MODEL	REV	CHANGE LIST	Model	CT3/5 MB BOARD	
			Page	FROM	TO
CT3/5 MB 31CT3MB0015 31CT3MB0031	1A	PAGE 2 --- Enable CLK48M from clocK generator for the PLL circuit of 7411, and disable the ocsillator circuit of PCI7411 PLL. PAGE 3 --- Remove H/W shutdown circuit that supported ADM1032. PAGE 4 --- Use X7R type to replace Y5V type for CPU Decoupling/Bypass capacitor. PAGE 10 --- Add a terminal resistor R706 for -CODE_RST# to improve signal quality. PAGE 11 --- 1. Add a 10K pull-up resistor on MCH_SYNC# for booting. 2. Change the power plane of PCIE_WAKE# from 3VSUS to 3V_S5 to solve system can't turn off issue. 3. Change the power plane of ICH_THRM# and SCI_# from 3VSUS to +3V to reduce leakage. PAGE 12 --- We can also use 5VSUS to instead of 5V_S5 to save cost of MOSFET(A06402). PAGE 15 --- Add a level-shift cicuit for EDID interface. PAGE 17 --- 1. Add a off-page and a EMI solution for CLK48M. 2. Remove the reserve resistors (R693~R695) of parallel interface for PCI1510. PAGE 18 --- Remove R696, connect controller and power switch directly . PAGE 19 --- Change R682&R683 value from 56 ohms to 0 ohm cause of BOM error at A-test. PAGE 22 --- 1. Change MC3 type from Y5V to X7R to improve

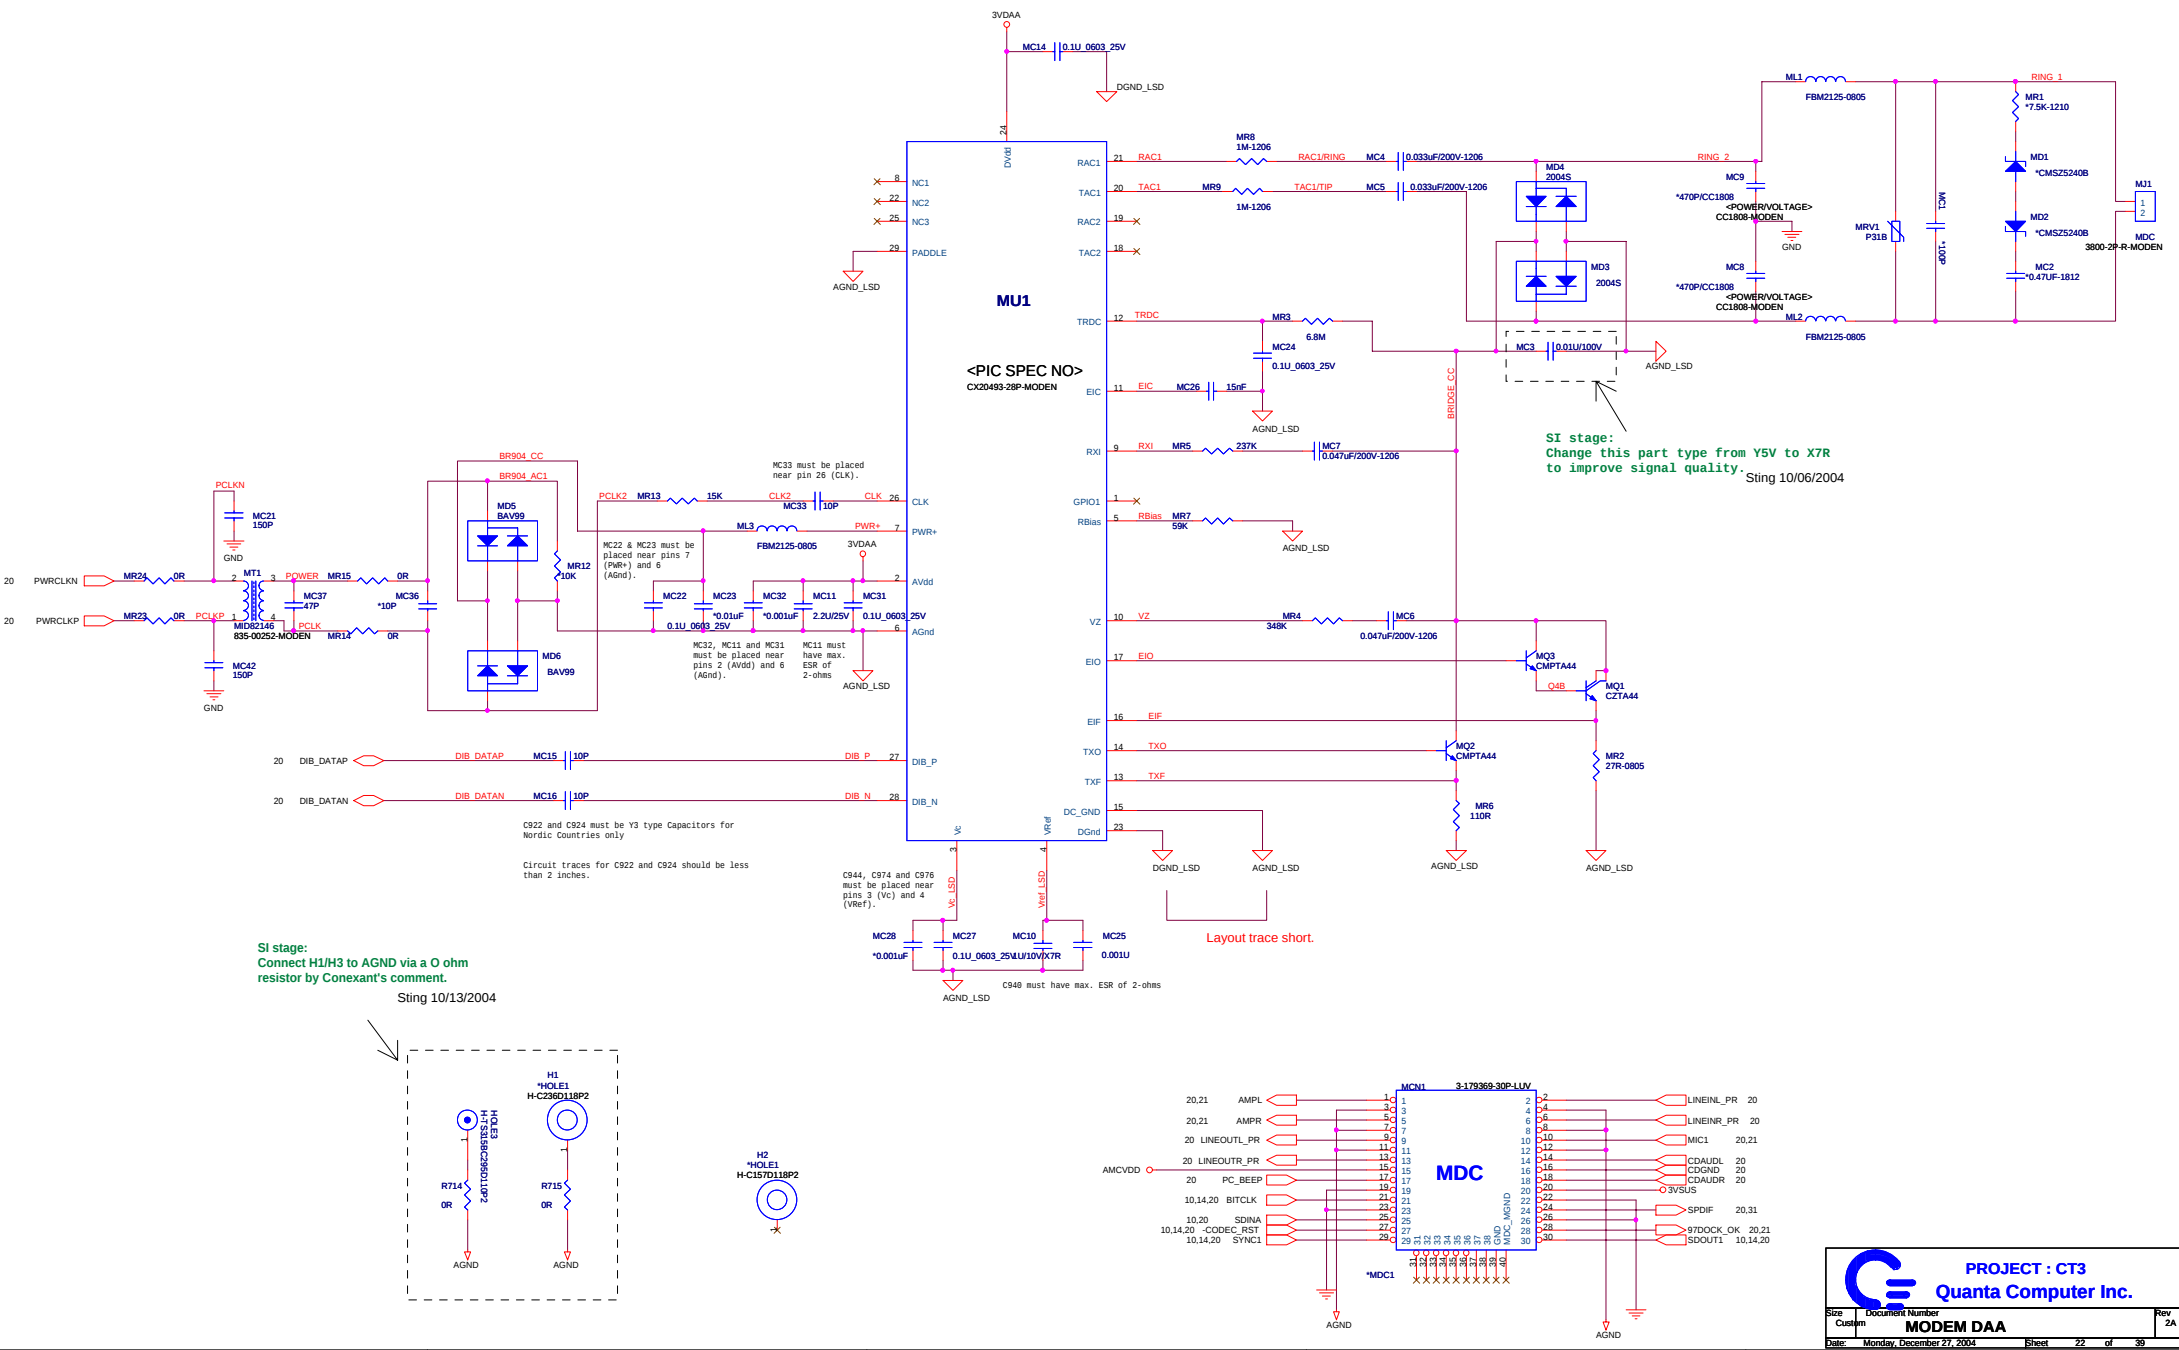
SI stage:
Connect H1/H3 to AGND via a 0 ohm resistor by Conexant's comment.
Sting 10/13/2004

SI stage:
Change this part type from Y5V to X7R
to improve signal quality.
Sting 10/06/2004

SI stage:
Modified transformer circuit for 10/100M application.

BATTERY CHARGER

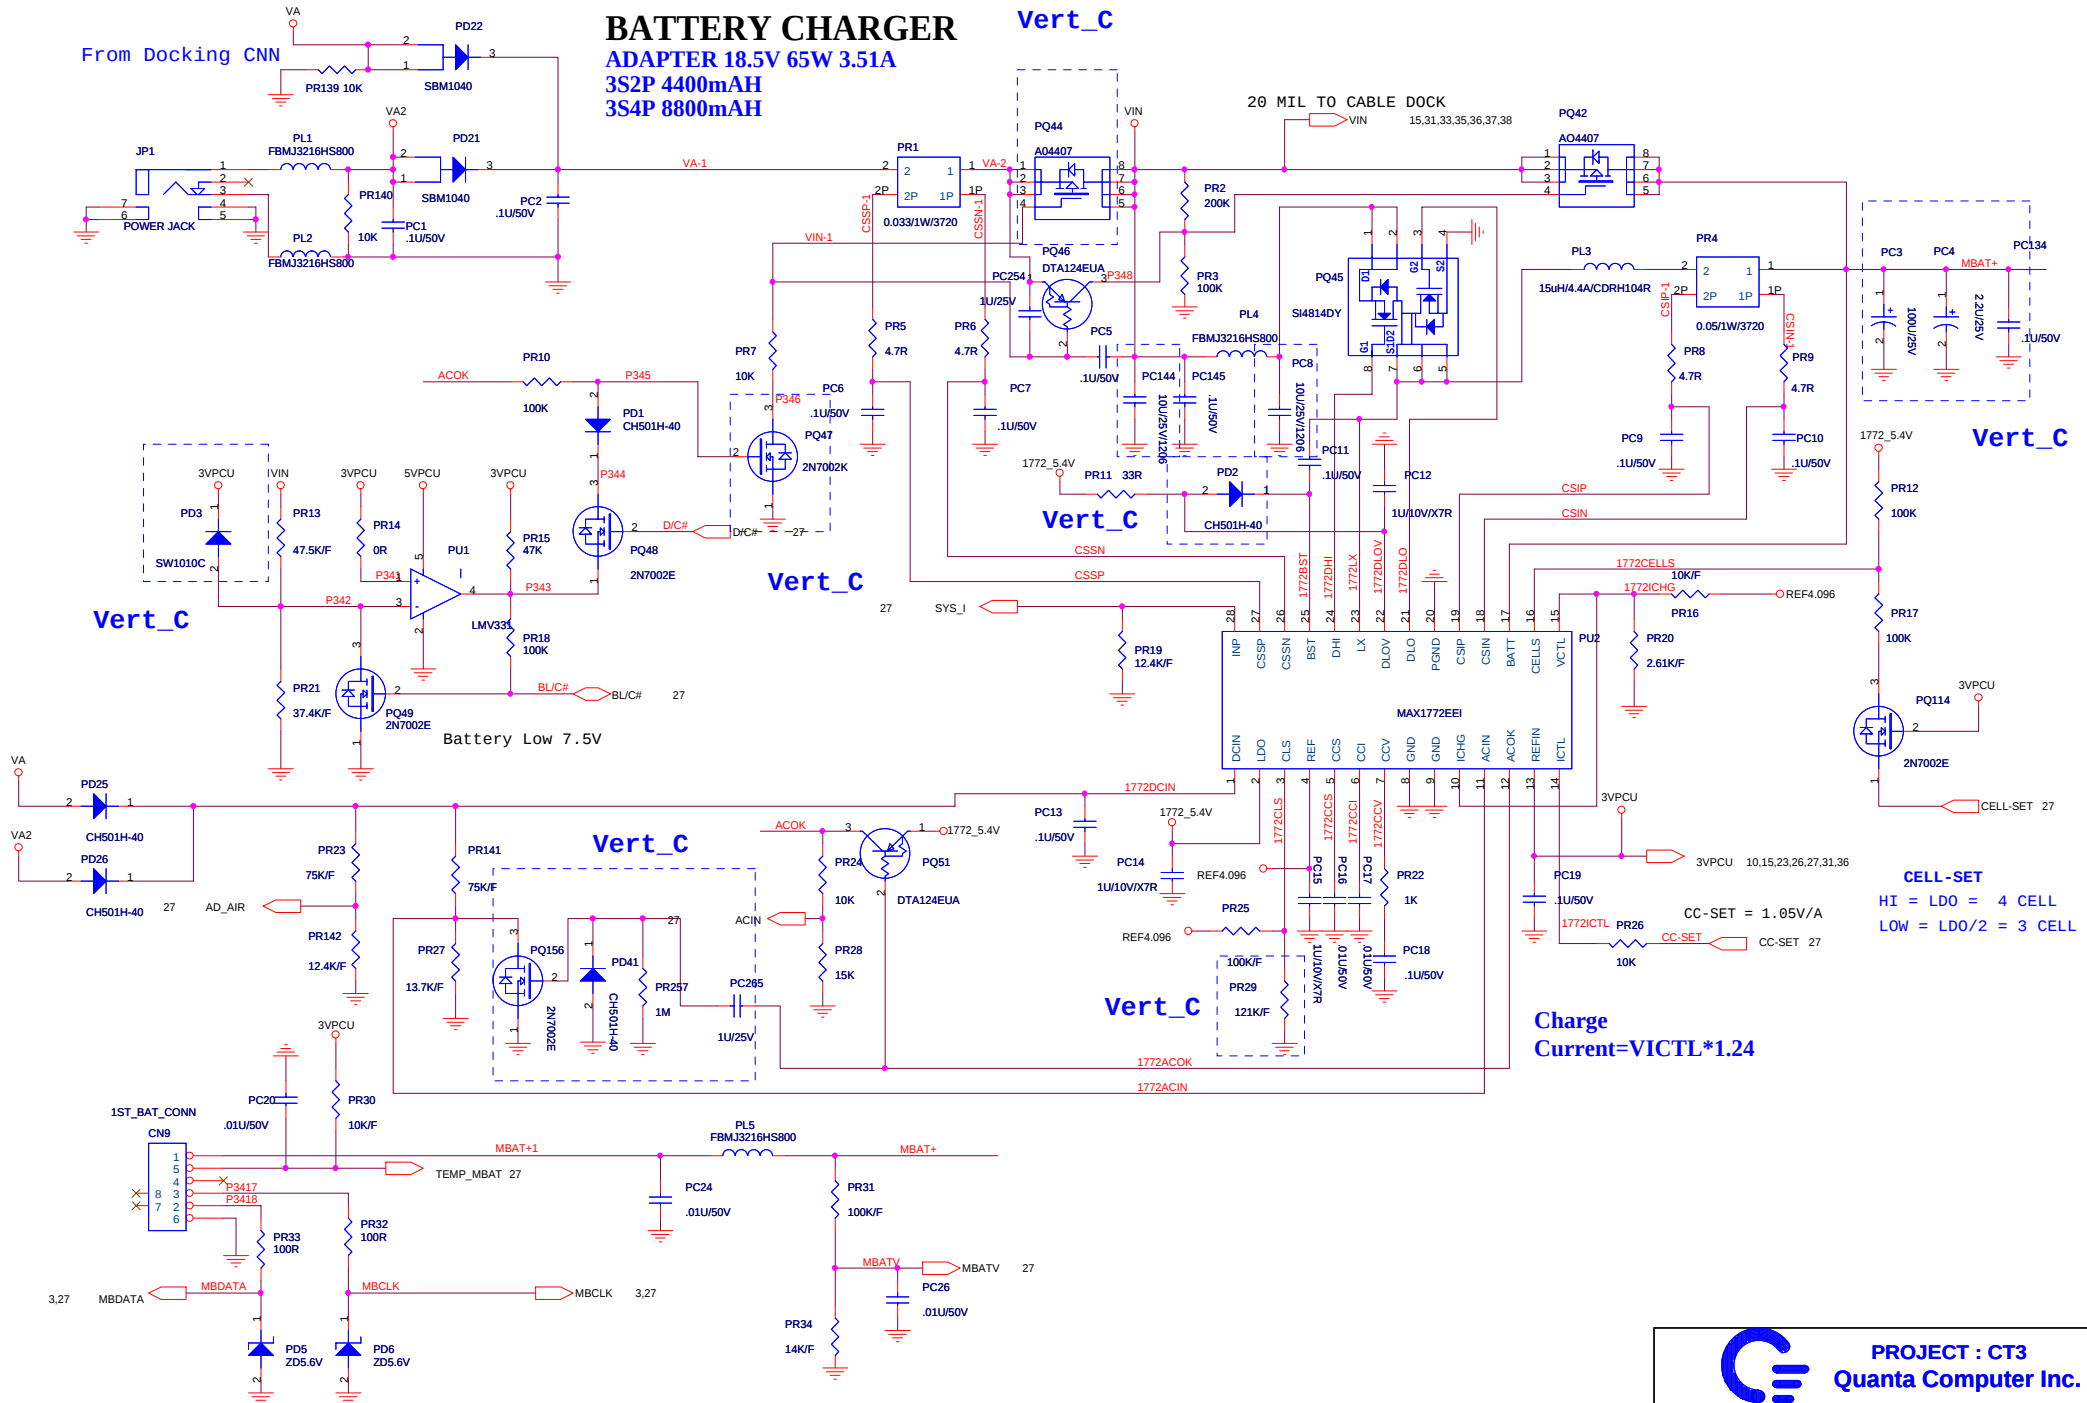
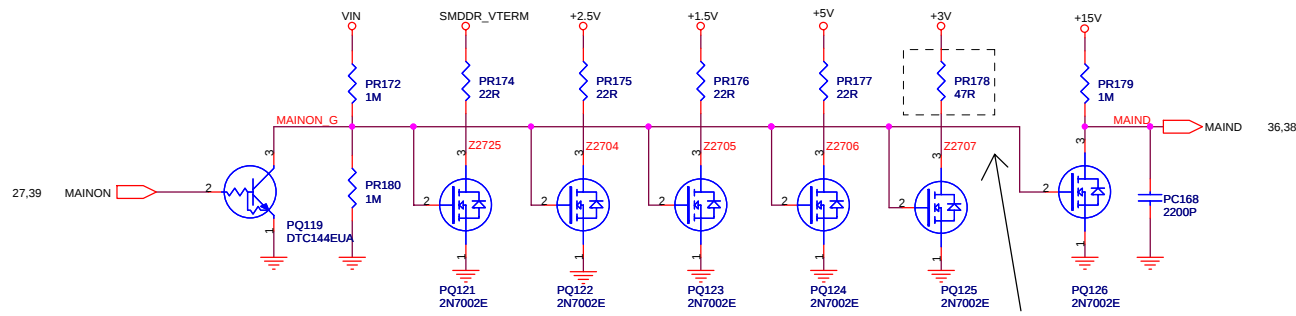
SI stage:
Change PR178 value from 22 ohm to 47 ohm, Intel has required the timing sequence of +1.5V and +3V in the system, we'd like to increase the value to make +3V discharge slowly to meet the specification of falling time.
